APPLICATION NO.	FILING DATE	FIRST NAMED INVENTOR	ATTORNEY DOCKET NO.	CONFIRMATION NO.
09/681,441	04/05/2001	Peter Fall	VCC0031-US	4762

Office Action Summary

Application No.
09/681,441

EXHIBIT 11

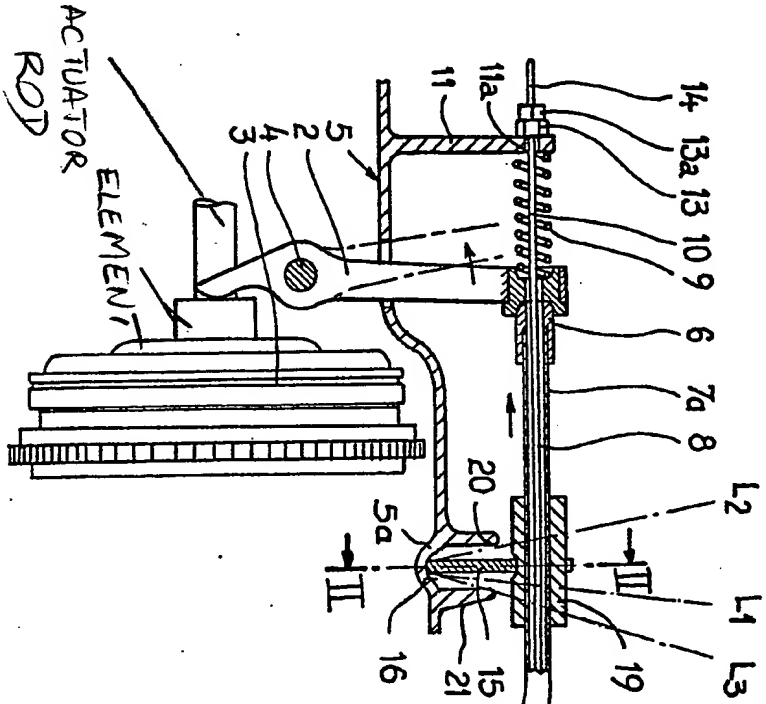
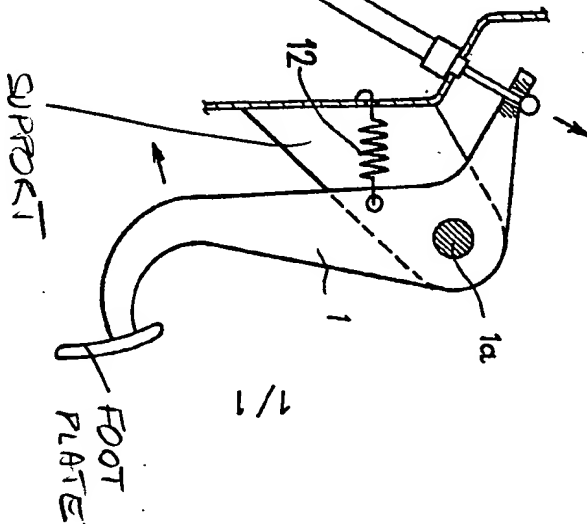
- a support (i.e., a bracket unnumbered at 12 in Fig. 2, see Exhibit attached) fixed in the cab;

- motion-transmitting element 7 that is joined firstly to the portion of the pedal arm 1 on the other side of the pivot axis 1a from the foot plate and secondly to a pivotally mounted lever 2 that is configured so that pivotation thereof actuates an operating device 3 fixed to an element (Exhibit) spaced from the support;

Regarding claim 6, the lever 2 is joined to a rocker arm 15, 19, which, when the lever 2 is pivoted, acts on an actuator rod (see Exhibit) for a brake servo unit 3, which is located on the outside of an intermediate wall 5 on the inside of which the support is located spaced from the intermediate wall 5.
